Appendix A

Field Change Requests

**NW Natural Pre-Remedial Design Data Gaps Sampling
US Moorings Project Area – Fall 2020
Field Change Request Form**

Field Change Request (FCR) Title: Subsurface Sediment Sampling Intervals for Alkylated PAH and TPH Analyses

Riverbank Photograph Log

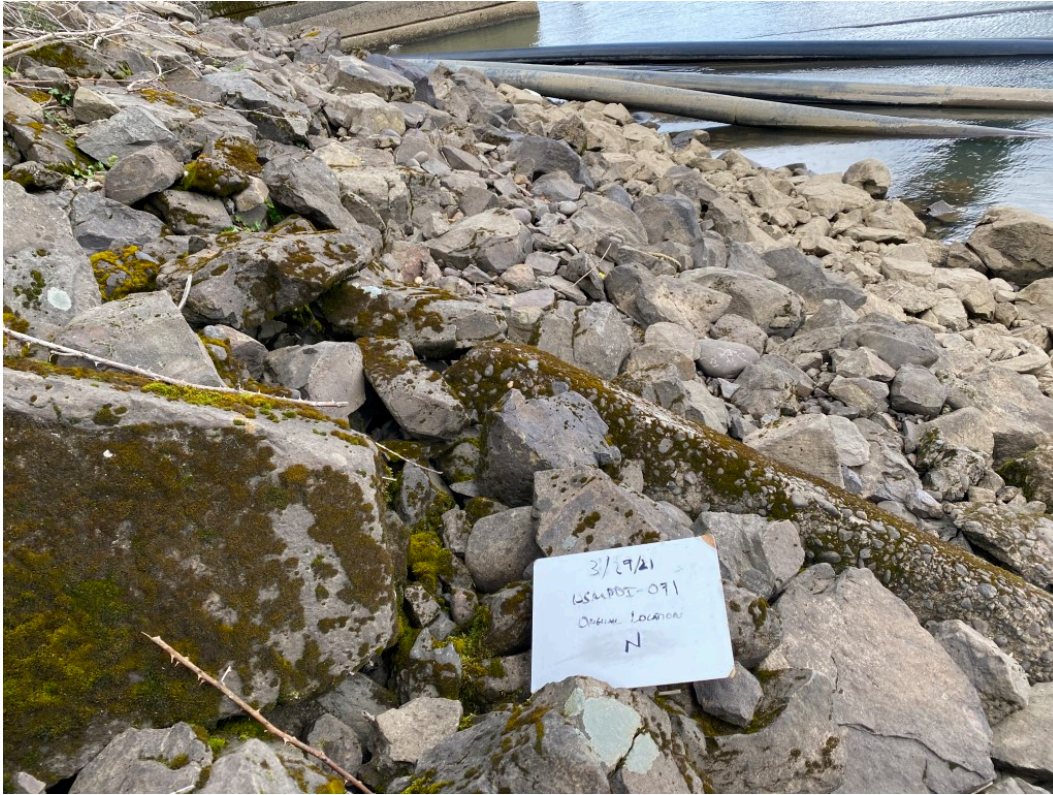
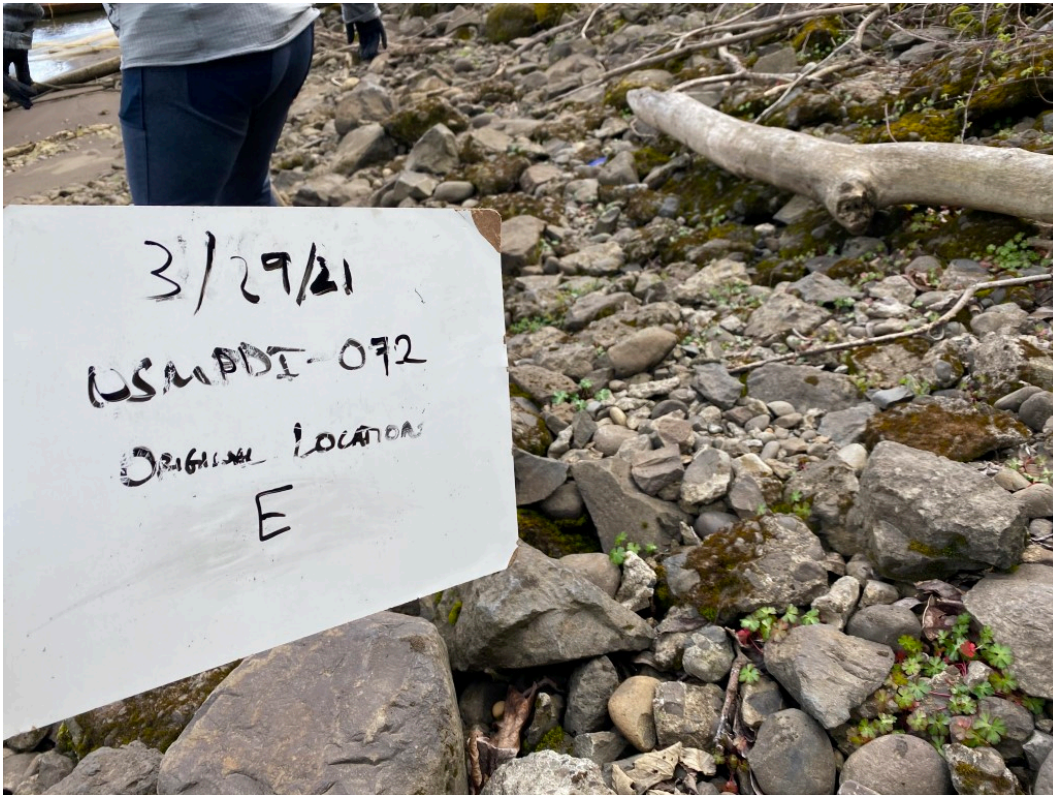
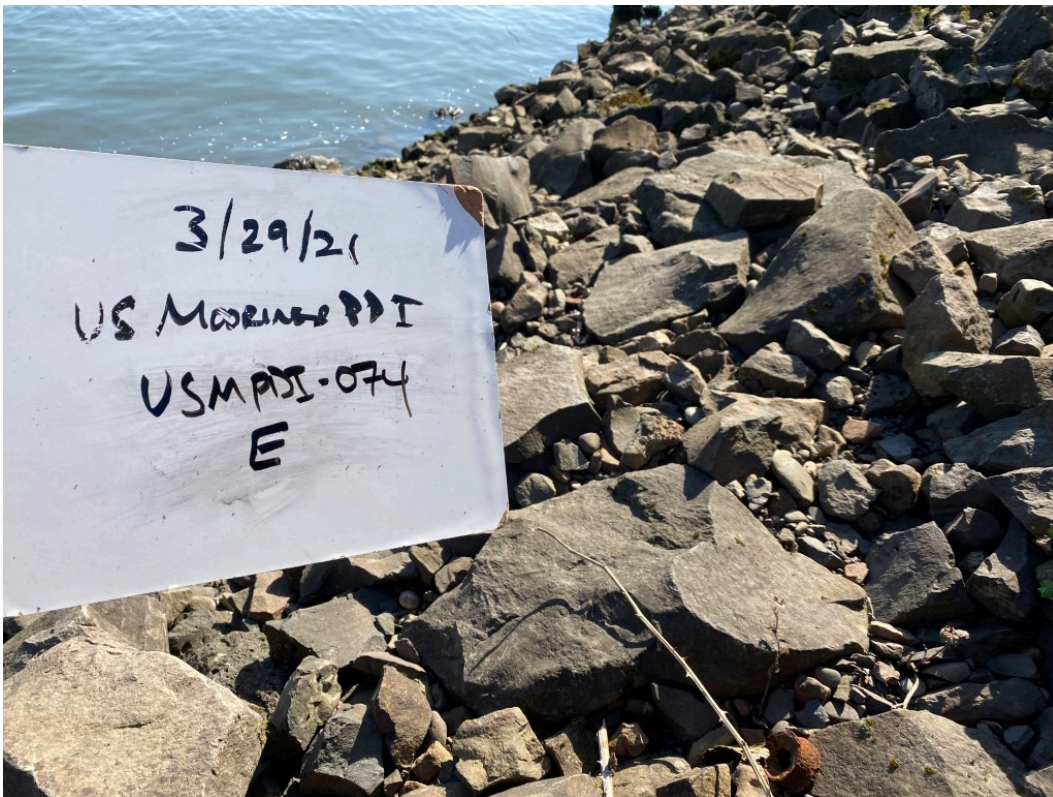
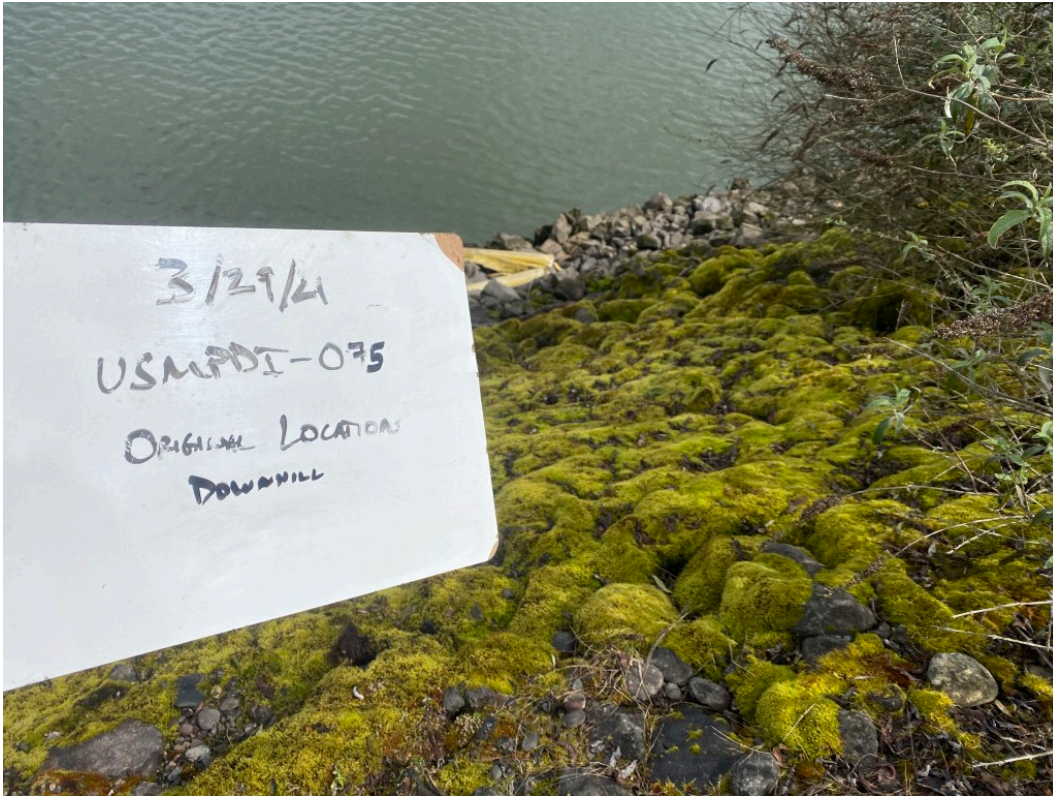
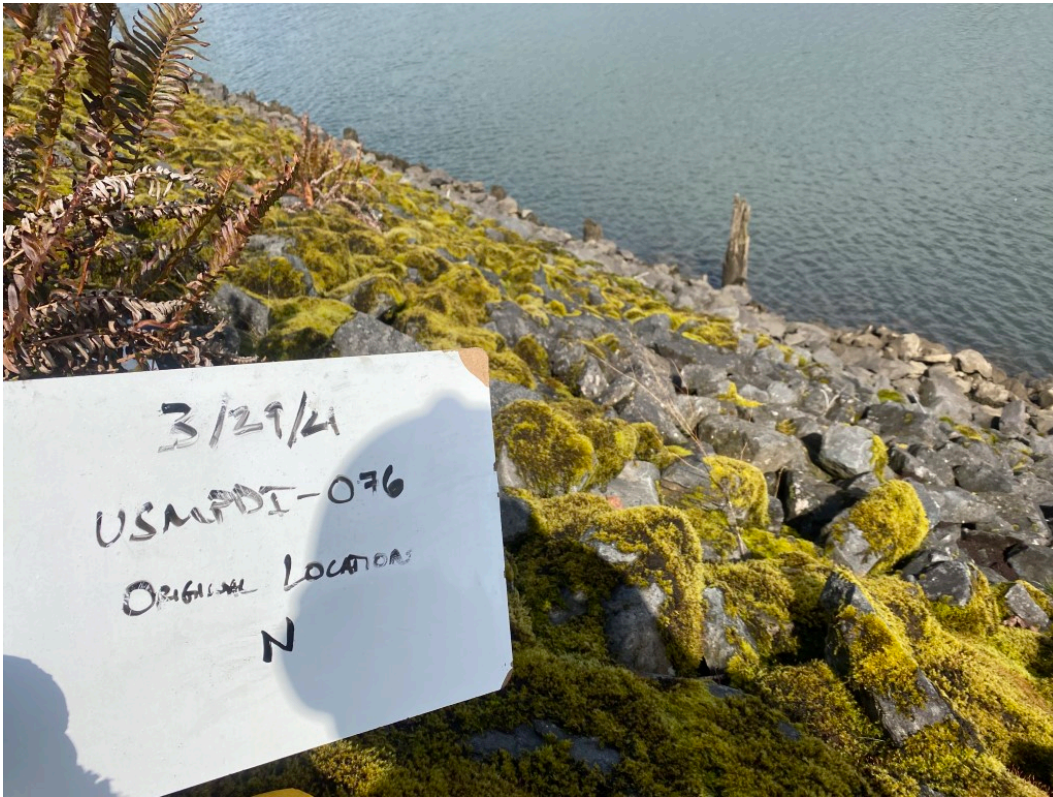
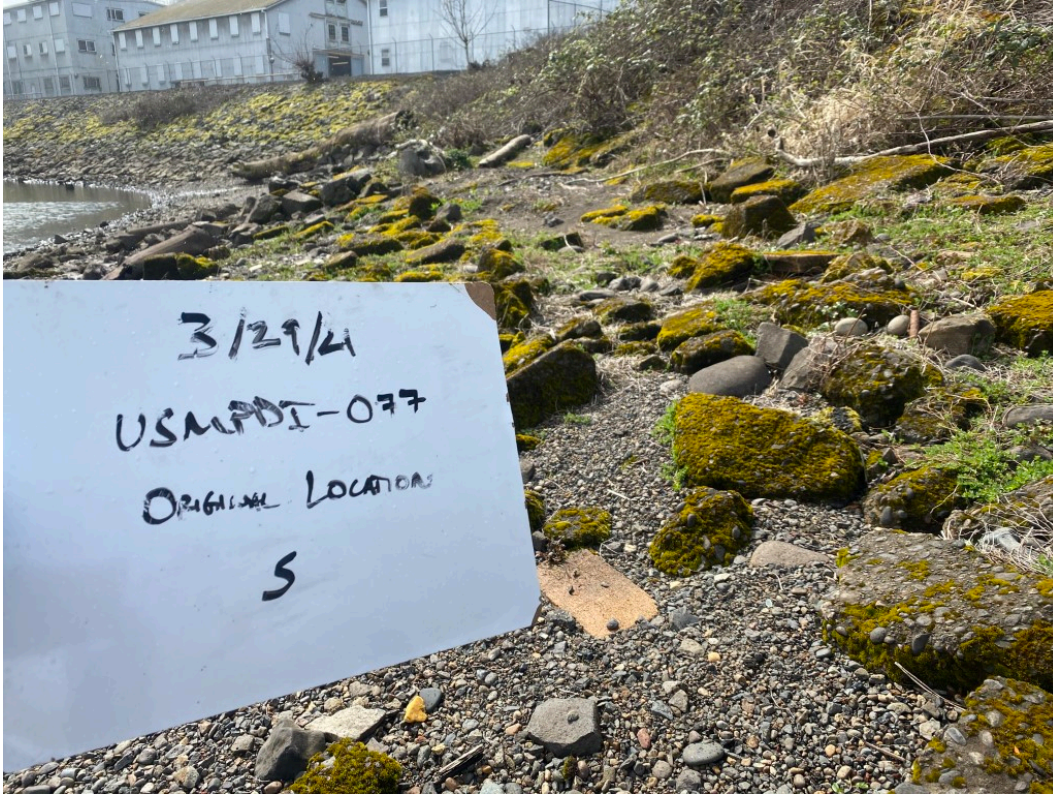
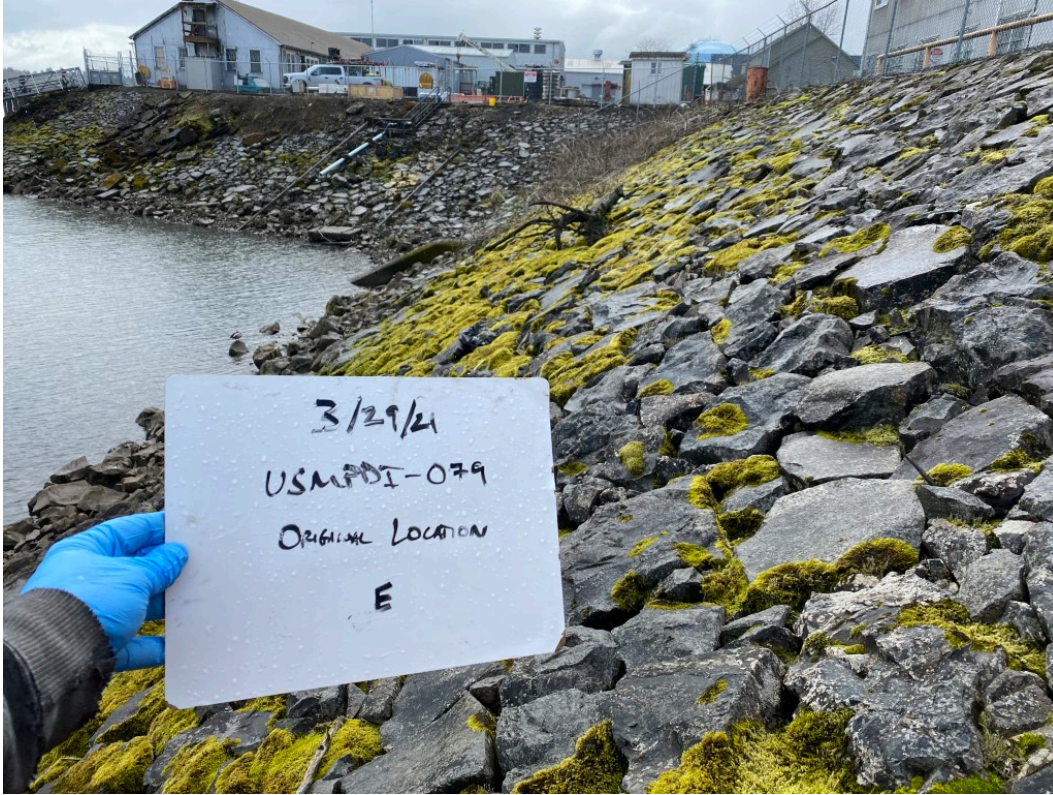
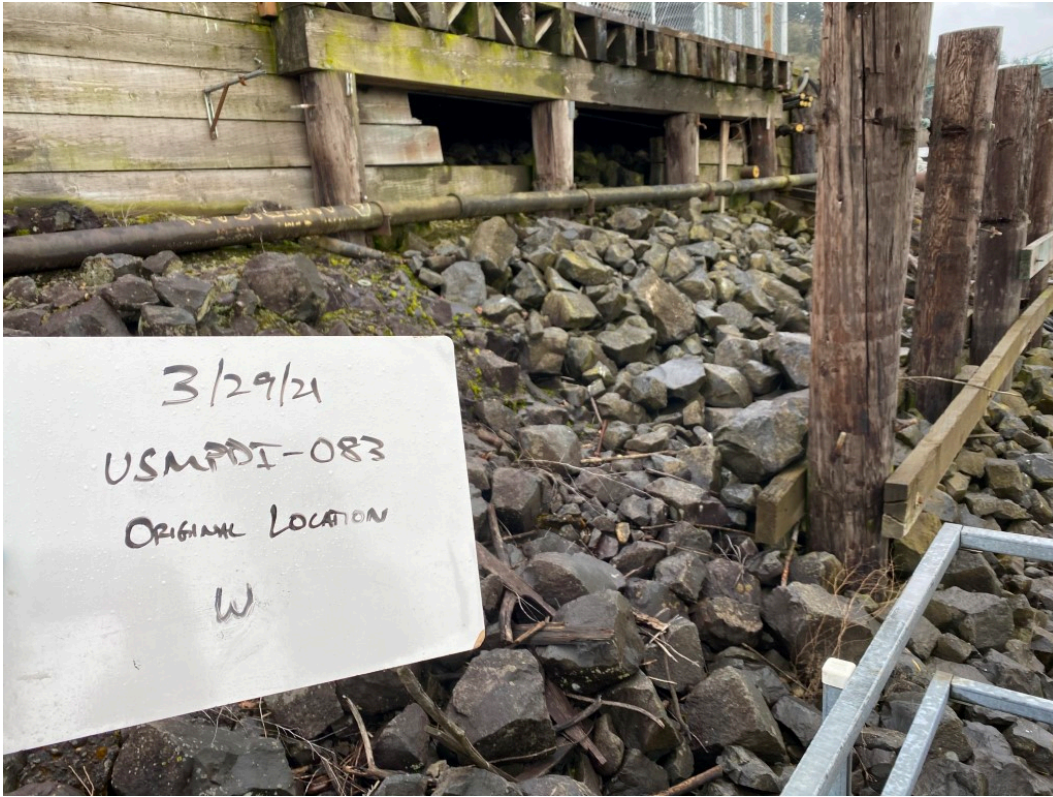
Recommended Change
<p>As verbally agreed with EPA oversight personnel during the visual reconnaissance, NW Natural proposes to abandon all riverbank surface soil locations other than USMPDI-073 and USMPDI-077 due to the lack of surface erodible soils, as photograph documented in Attachment A. In addition, due to the small area of potentially erodible solids at locations USMPDI-073 and USMPDI-077, a two-point composite grab sample was homogenized to create the sample at these locations, and the mid-point of the two samples will be used as the sampling location.</p>

Figure 1
Revised Surface and Subsurface Sediment Sampling Locations
 Field Change Request No. 4
 US Moorings Project Area
USMS0031905

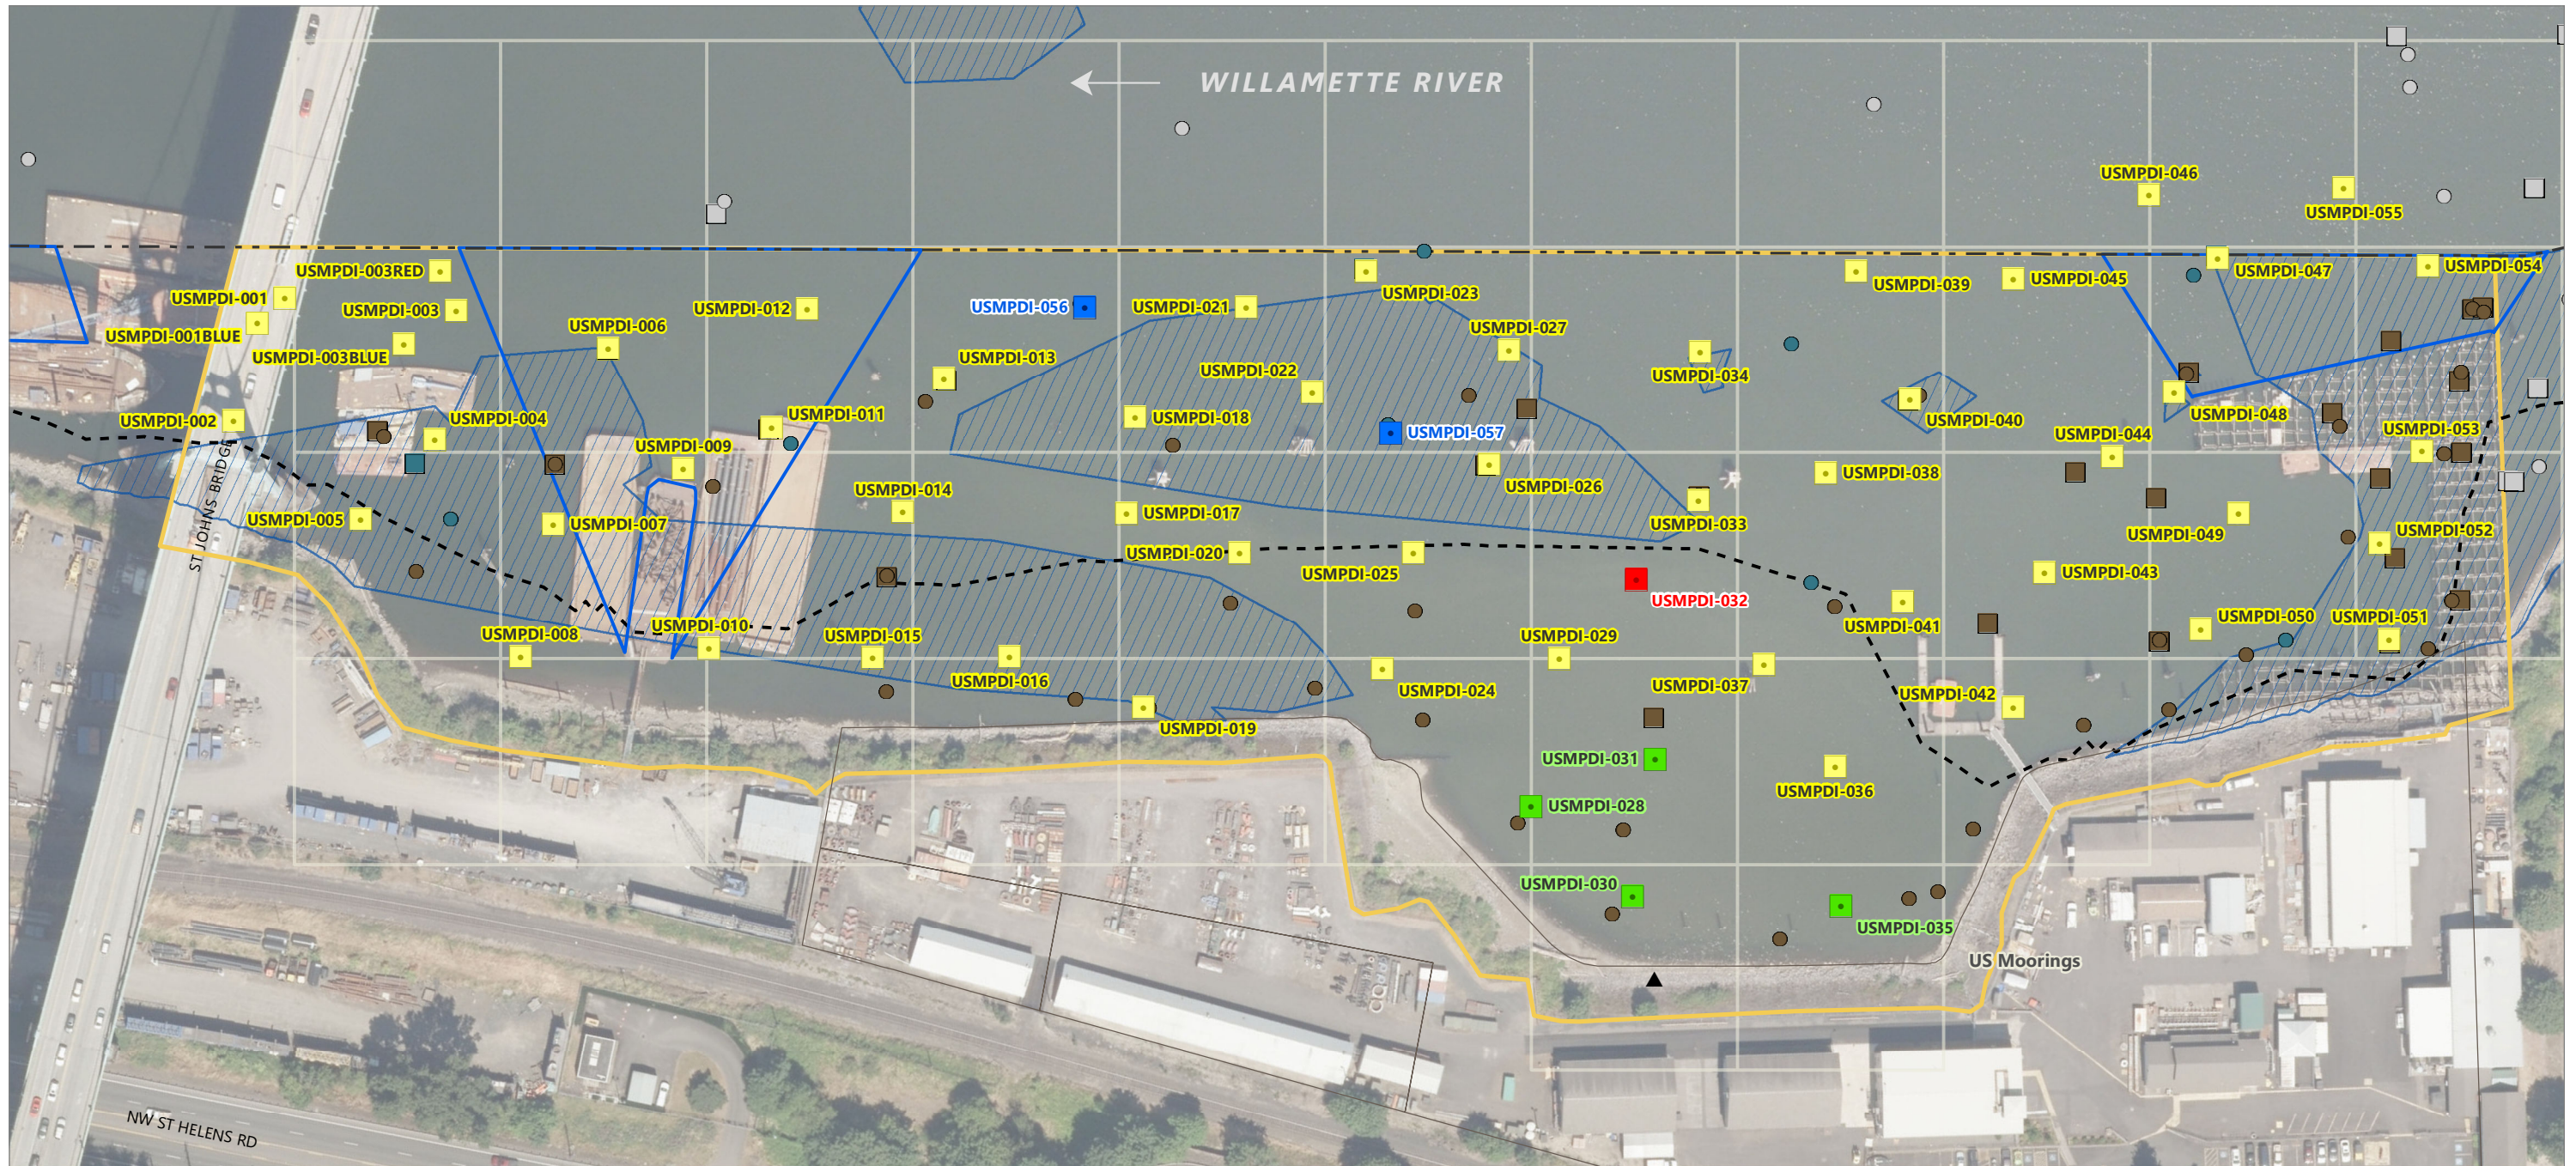
Recommended Change
<p>NW Natural proposes to remove station USMPDI-032 from the PDI sampling program due to sufficient data density in this area and to use an 8-foot coring assembly to collect stations USMPDI-028, USMPDI-030, USMPDI-031, and USMPDI-035 due to anticipated shallow refusal and insufficient river water surface elevations to collect the proposed 16-foot cores.</p>
